Item Name: Fwd Crosstube - Mid Height 206L / L1 / L3 / L4, Blue

DART AEROSPACE LTD		Work Order:	135690
Description: Crosstube Mid Fwd (206L)		Part Number:	D206-667-107
Inspection Dwg: D206-667-147 Rev: A		Page 1 of 1

DRAWING NO. D206-667-147	TITLE CROSSTUBE ASS'Y (206L MID FWD)	REV. A	DART AEROSPACE LTD ENGINEERING ORDER		D.E.O. NO. D206-667-147-A-1	SHEET NO. SHEET 1 OF 1	SCALE NTS
DRAWN <i>q</i>	CHECKED <i>ASS</i>	MFG. APPR. <i>JB</i>	APPROVED <i>MD</i>		DE APPR. <i>MD</i>		
DATE 11.07.15	DATE 11.07.20	DATE 11.07.21	DATE 11/07/21		DATE 11.07.21

DRAWING NO. D206-667-147	TITLE CROSSTUBE ASS'Y (206L MID FWD)	REV. A	DART AEROSPACE LTD ENGINEERING ORDER		D.E.O. NO. D206-667-147-A-2	SHEET NO. SHEET 1 OF 1	SCALE NTS
DRAWN AJS	CHECKED	MFG. APPR.	APPROVED	DE APPR.			
DATE 12.08.02	DATE 12.08.02	DATE 12.08.02	DATE 12.08.02	DATE 12.08.02	DATE 12.08.02

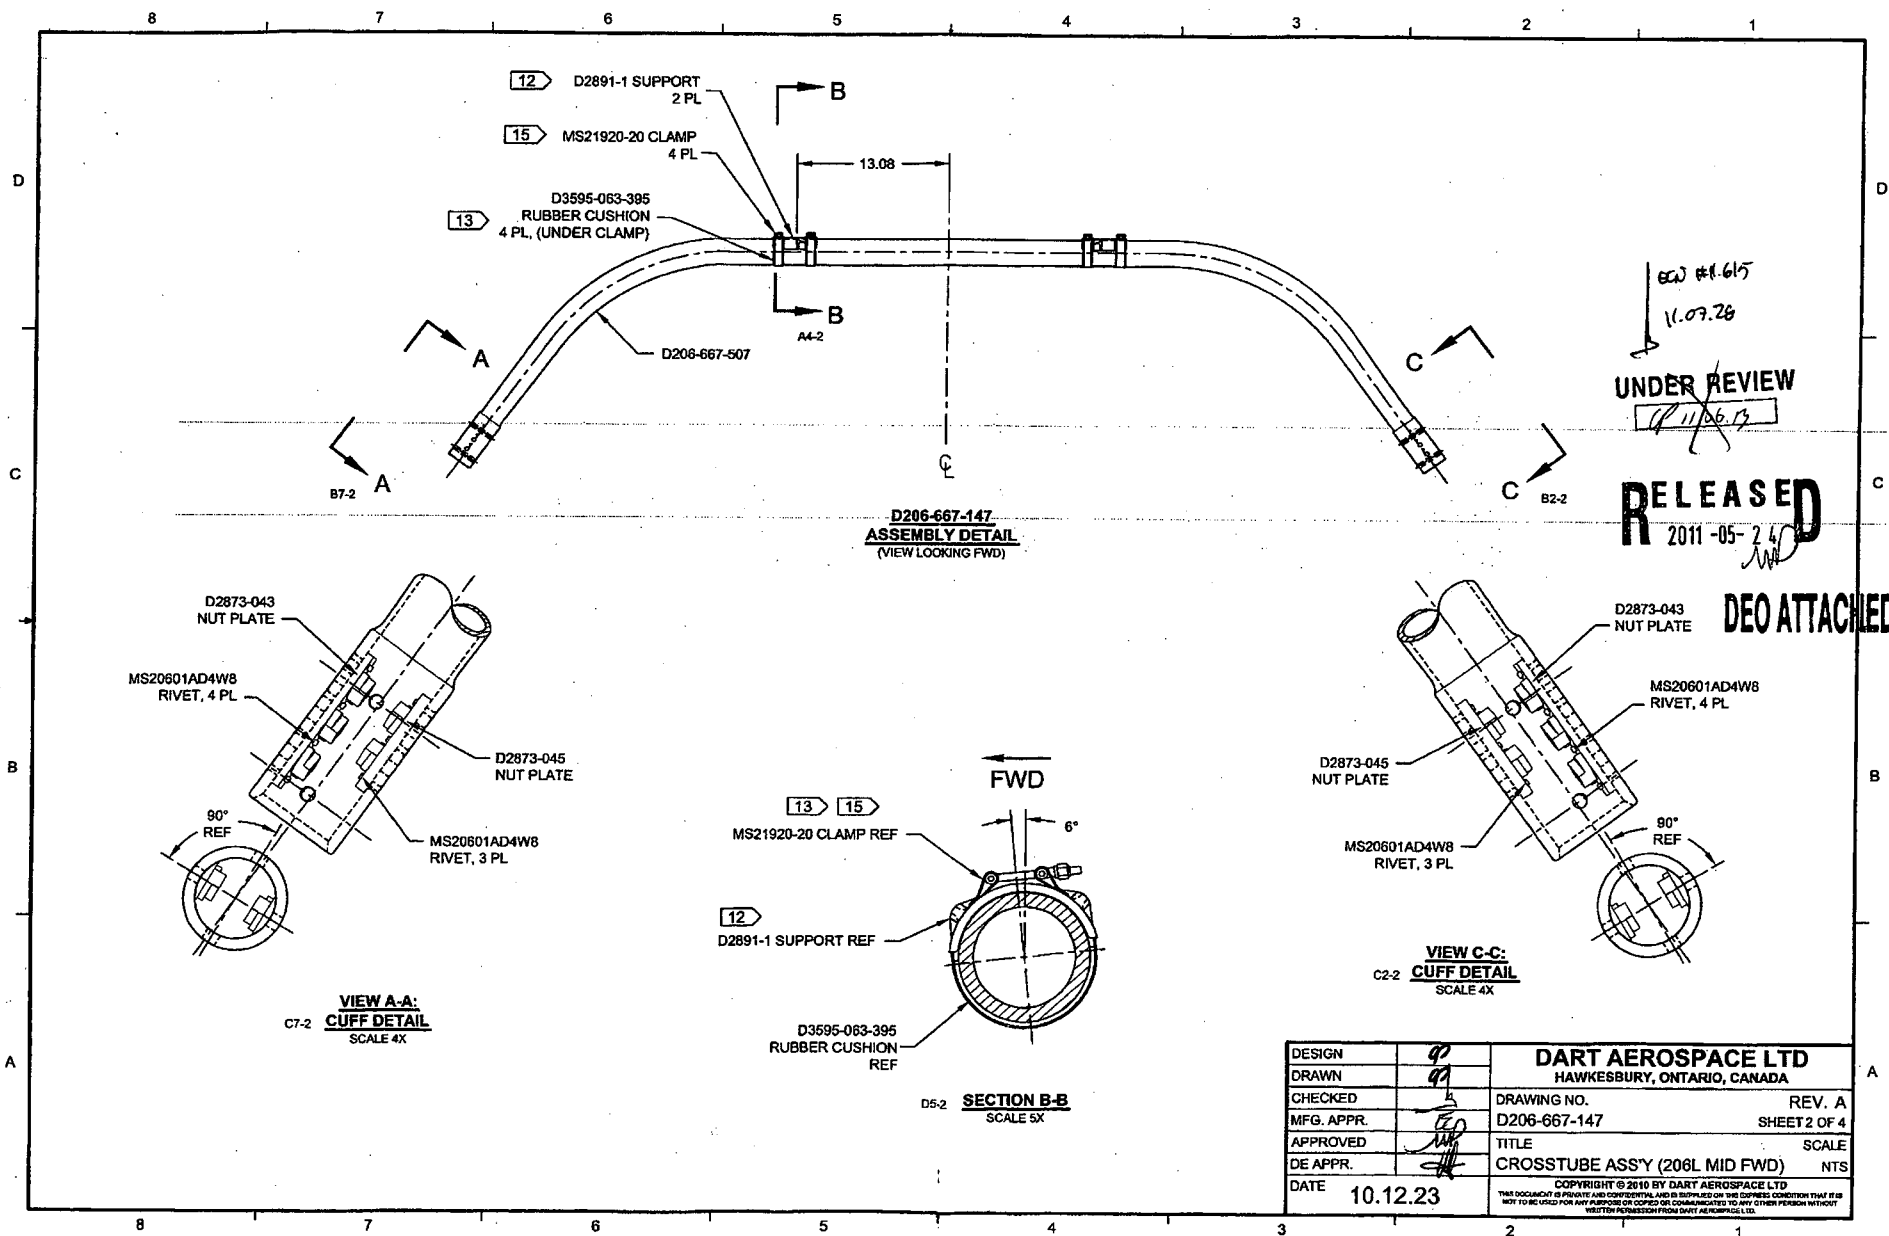
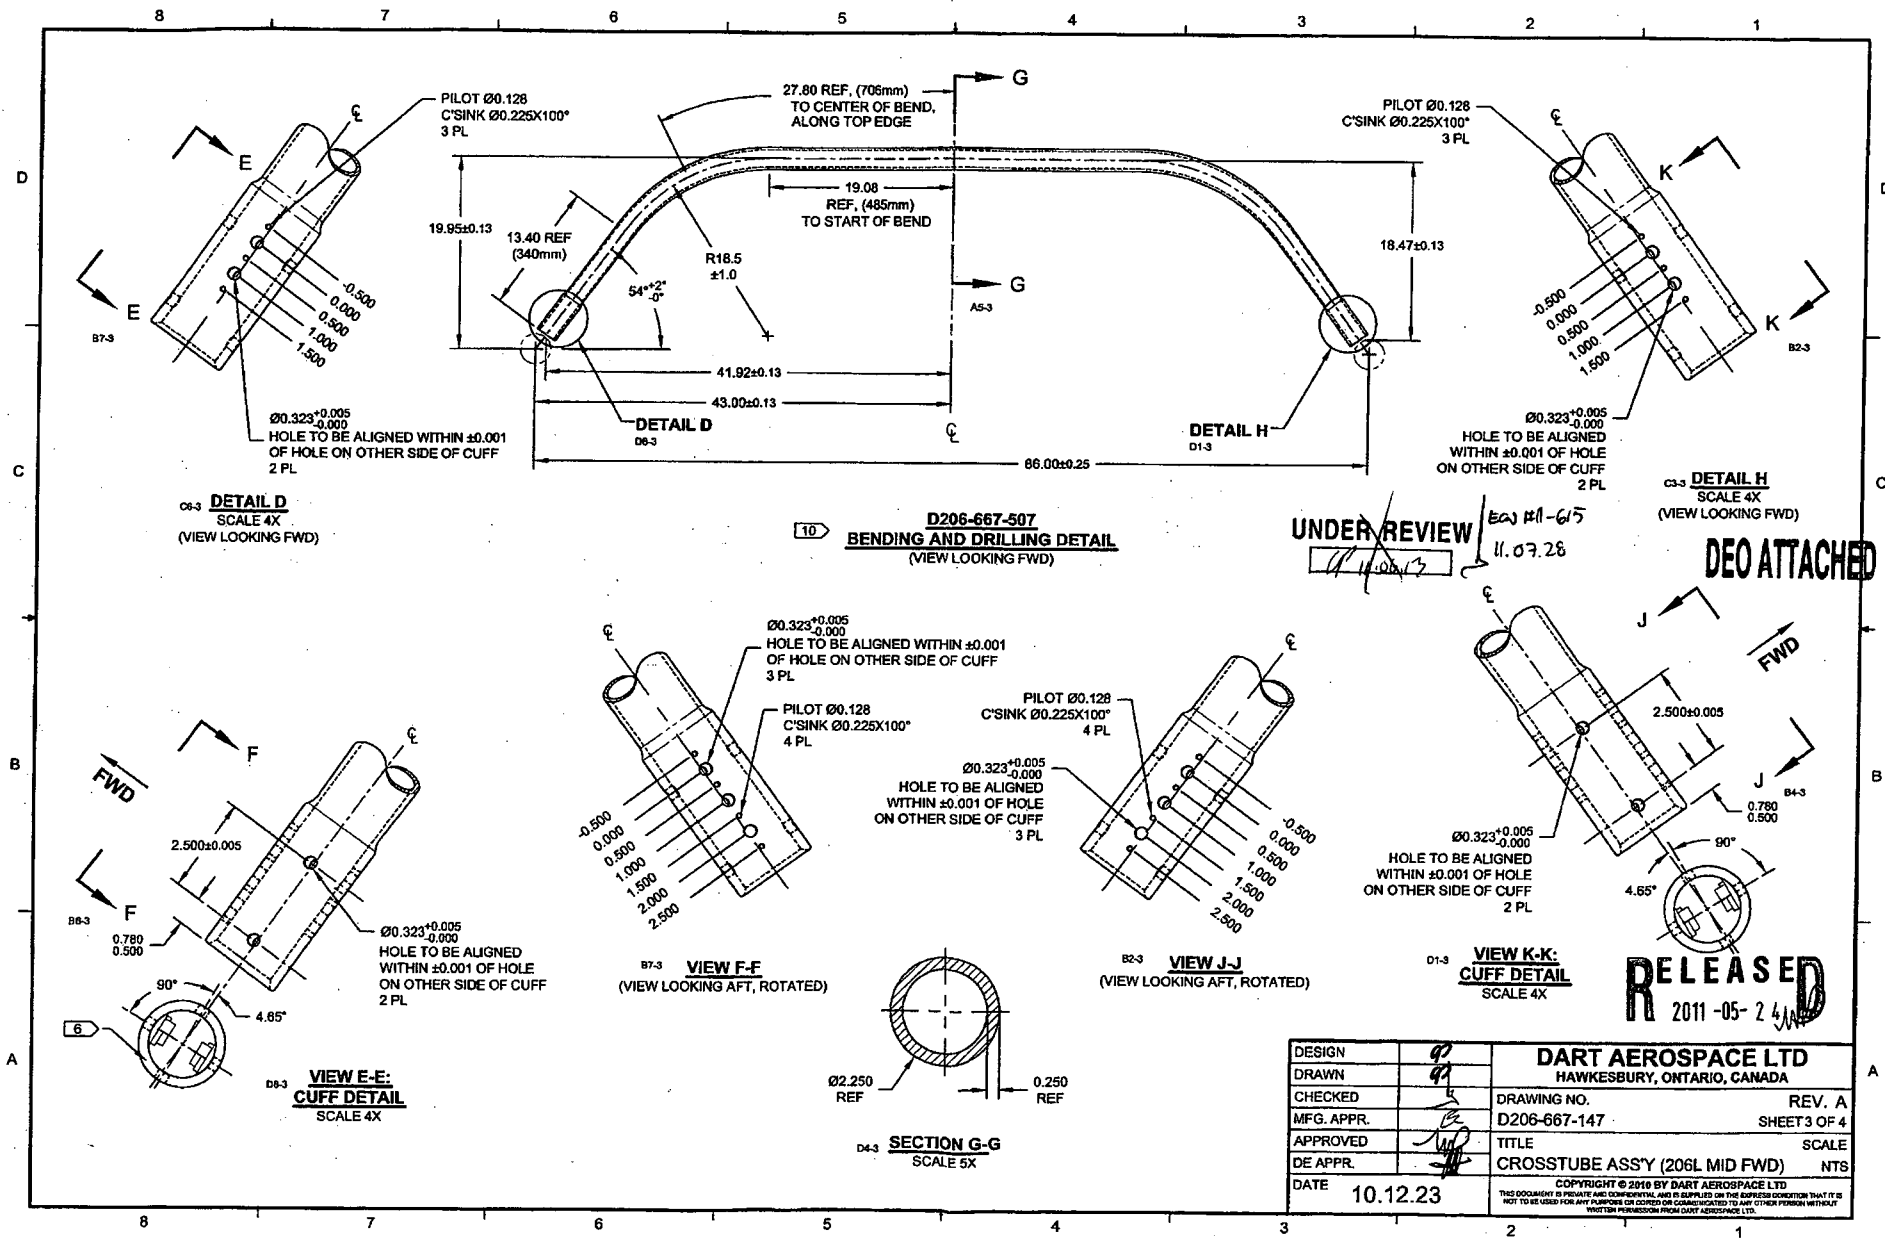
PURPOSE:

REPLACE MAGNOBOND WITH PROSEAL.

NOTE 12 & 15, SHEET 1 IS AMENDED AS FOLLOWS:

12) TO INSTALL D2891-1 SUPPORT: ABRABE MATING SURFACE OF SUPPORT AND CROSSTUBE WITH 180-GRIT SANDPAPER AND REMOVE RESIDUE WITH MEK (OR EQUIVALENT). APPLY A 0.04" TO 0.07" THICK LAYER OF PROSEAL 890 CLASS B-2 (OR AMS-S-8802 CLASS B-2) SEALANT TO MATING SURFACE OF SUPPORT.

15) TORQUE CLAMPS 80 TO 100 IN-LB. ENSURE AT LEAST 1.5 THREADS SHOWING IN SAFETY AND THAT NUT HAS NOT BOTTOMED-OUT AFTER TORQUING. **PRIOR TO PACKAGING, RE-CHECK TORQUE ON CLAMPS AFTER PROSEAL 890 SEALANT HAS CURED FOR 72 HOURS.**

DETAIL P
BONDING STRAP INSTALLATION 2 PL

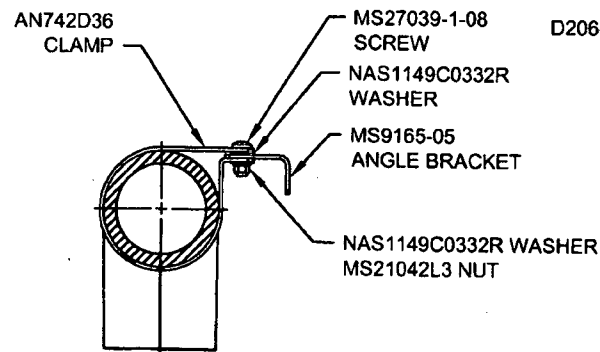
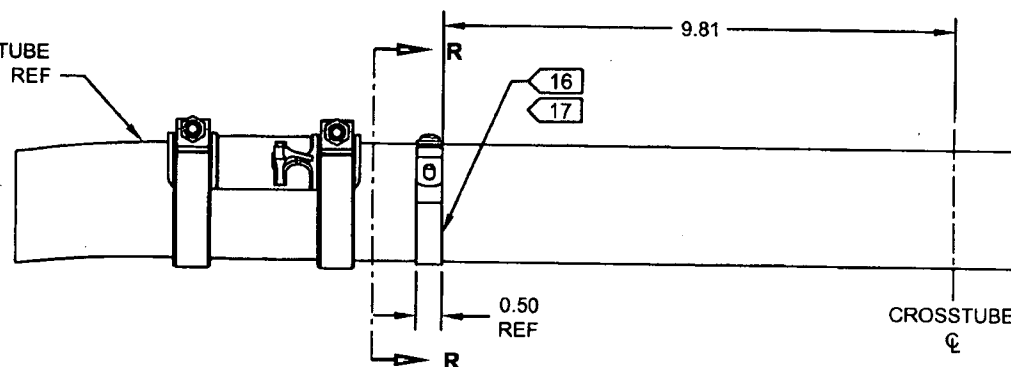
PURPOSE:

ADD ELECTRICAL GROUNDING STRAP

ADD

- 16) MASK AREA UNDER CLAMP PRIOR TO PAINTING
- 17) SEAL EDGES WHERE AN742D36 CLAMP MEETS WITH THE CROSSTUBE USING SIKAFLEX-241/-291 OR MIL-S-8802 CLASS B2 OR PROSEAL 890 SEALANT
- 18) PERFORM RESISTANCE CHECK TO ENSURE MAX RESISTANCE IS 10 MILLIOHMS
